# Reponses to Feedback on Channel Bonding Proposal

Steve Shellhammer and Patrick Stupar (Qualcomm)

# Abstract

### Alternative approach to having CBS read the LLID

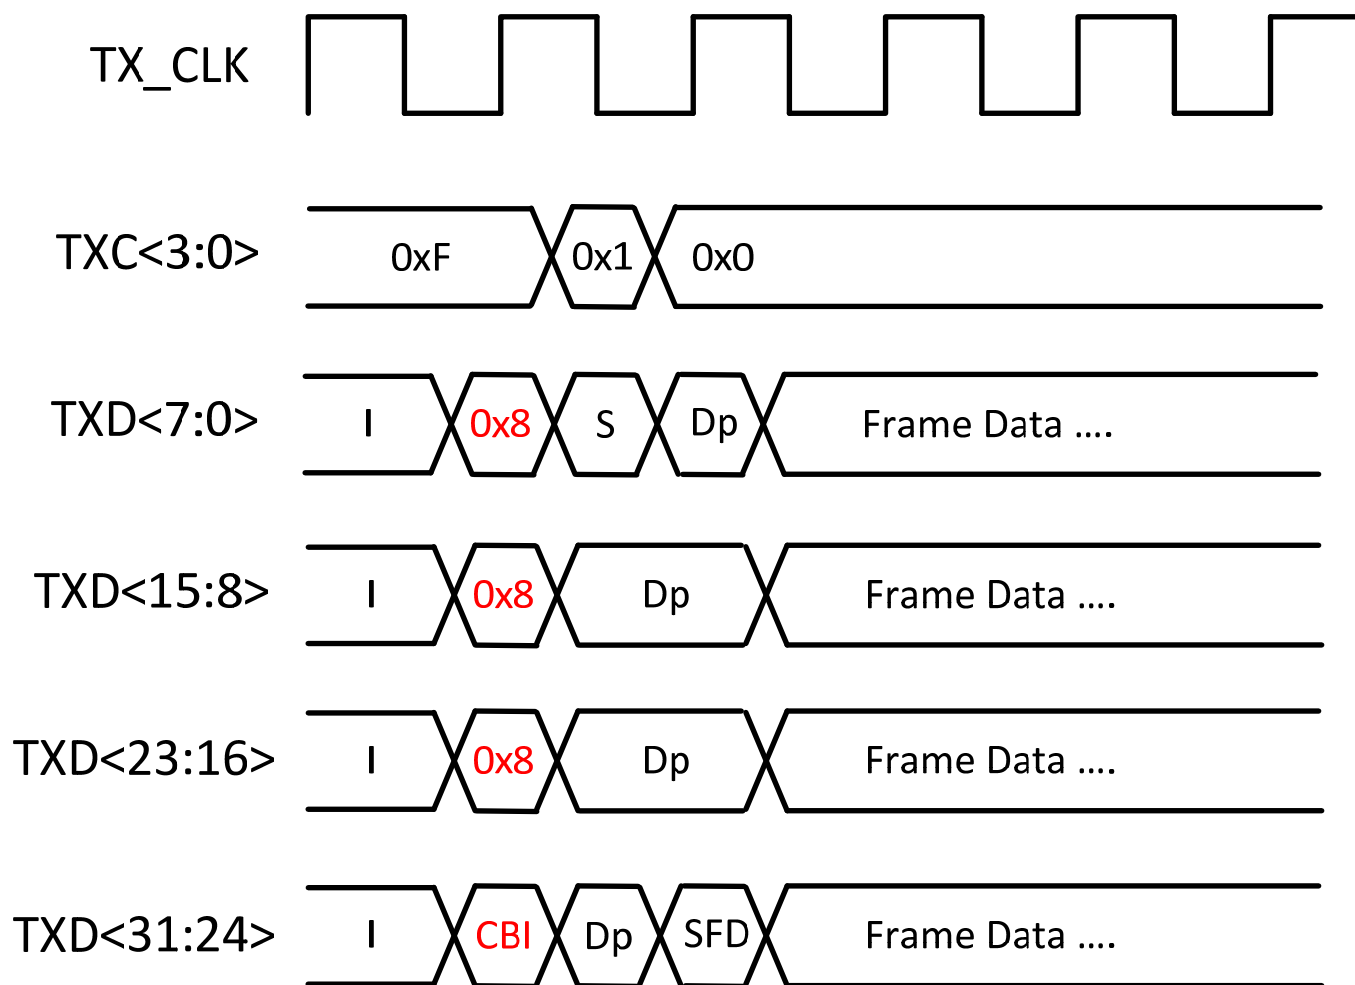
- When the channel bonding sublayer reads the LLID upon transmit, does that represent a layer violation?

- The Channel Bonding sublayer and the Reconciliation sublayer are both within the Physical Layer, and hence the reading of the LLID by the Channel Bonding sublayer is not a layer violation
- If the TF prefers, there is an alternative proposal in the next few slides does not require the CBS to read the LLID

- Signaling channel bonding interface number over XGMII
  - Similar approach to signaling a low power idle (LPI)
  - In Table 46-3 [2] a TXC = 1 and TXD = 06 on all lanes request an LPI
- Set TXC = 1 (indicating control character, not data character)
- Set TXD = specified value (e.g. 08) in lanes 0-2 to indicate channel bonding interface (CBI) number in TXD (lane 3)
- Set TXD = CBI number in lane 3 to indicate channel number
- The channel bonding sublayer (CBS) directs the frame to the CBI indicated in lane 3 of TXD

- This is a change to the Reconciliation sublayer
- The LLID mapping to CBI is moved to the RS sublayer
- This avoids the CBS from having to read LLIDs
- The CBI signaling is placed just prior to the preamble of the frame on the XGMII
- This signals the CBI number for that frame
